# J. H. Fletcher & Co.

# Important Safety Notice

Subj.: Retrofit - Pressure setting on RRII/DDO

## CABLE REEL VALVE UPDATE

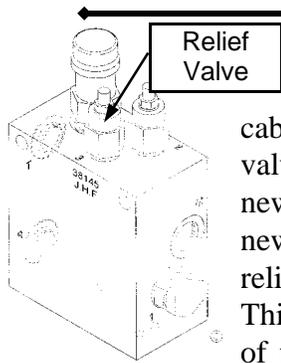
Over the last year J.H. Fletcher & Co. has changed its cable reel valve. The original valve was part number 37811 the new part number is 38145. The new cable reel valve incorporates a relief as a brake in the valve body. This will prevent any backlashing of the cable, while the operator is

using the cable reel function.

If you order the old part number today from our service department you will receive the new part number in a kit (part number 38225). Remember, when you get the new part you will not need the sequence valve in the circuit because it is incorporated into the new valve assembly.

## Parts Book Correction

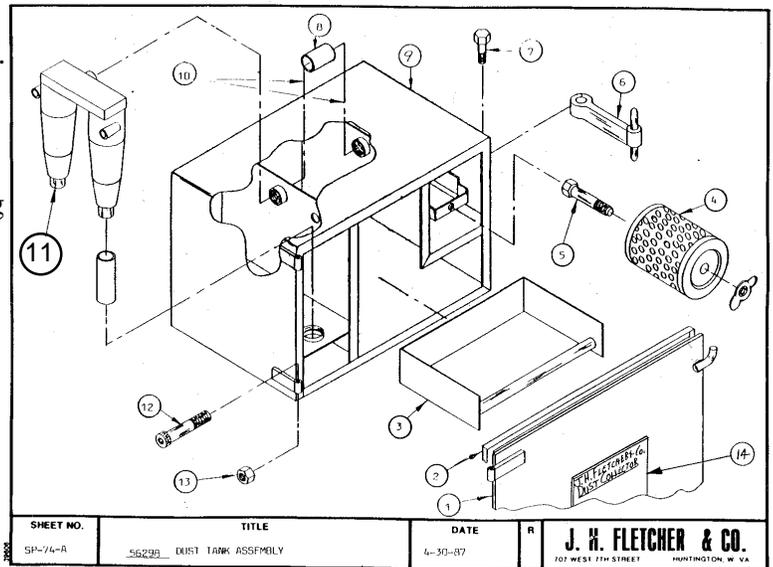
The dust tanks on your Fletcher roof bolting machines are manufactured by J. H. Fletcher & Co. The dust tank assembly drawing is found in your parts book and is labeled as drawing SP-74-A. It has come to our attention that prior to April 1997 the cyclone identified as number 11 on the drawing was incorrectly identified on the parts sheet as part number 56231. The correct part number should be 56272. Please make the appropriate correction in your parts book or call the Parts Book department for the correct parts sheet. We apologize for this error and any problems this may have caused. If you have any questions regarding the dust collection system, please contact Ben Pack at J. H. Fletcher & Co. (304) 525-7811.
